BULLETIN #103

APRIL 25, 1989

P-36 AND P-37 KITS

P34630 WASHERS

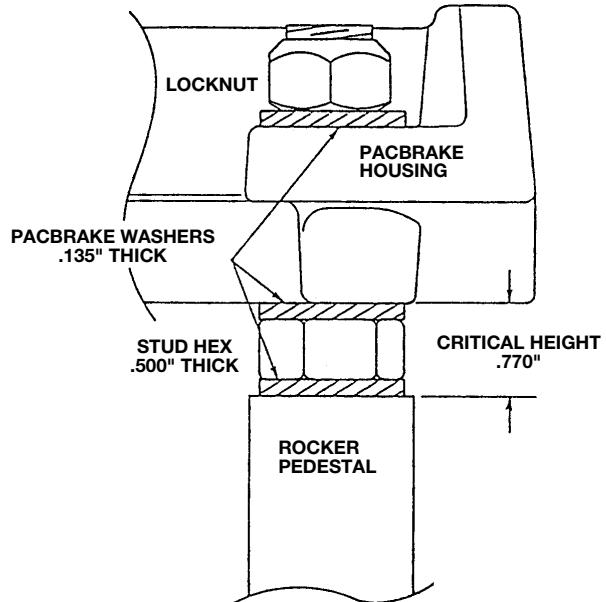
In order to make this portion of the brake installation easier for mechanics, we have decided to include 12 - P34630 washers, instead of 8, in all kits commencing March 10, 1989. This simply means that the 4 Caterpillar washers removed with the head bolts from the rocker shafts, will now be discarded and NOT reused as has previously been the practice.

By using ALL Pacbrake P34630 washers ground to .135" thickness - 3 to each stud - there can be no chance of a thicker or thinner washer being placed in a position which could affect the correct working height of the brake housing.

Please note that the Jacobs Mfg. Co. uses both thicker and thinner washers than ours, as well as shim packs on their earlier models. None of these are compatible with the Pacbrake kits and MUST NOT be used.

With reference to the diagram, it will be readily appreciated that should a thicker washer than .135" be used in either location between the brake housing and pedestal, then the housing will be positioned too high. If this allowed to occur, then the slave pistons may become over extended, causing the circlip to be forced from the housing. This can cause engine or engine brake damage.

Conversely, should a washer less than .135" be used, or even left out altogether, in either location, then there is a danger of the rockers contacting the underside of the brake housing, and/or our locating pin having insufficient clearance. Serious damage to the rockers, shaft or pedestal may result.

It is also advisable to check the centre pedestal head bolts on each rocker shaft, even though they may not have been disturbed during installation of the engine brake. These have been found on occasion to have 2 washers under the head, and if left unchecked, will cause the housing to be high centered on the capscrew head, with obvious unsatisfactory results.
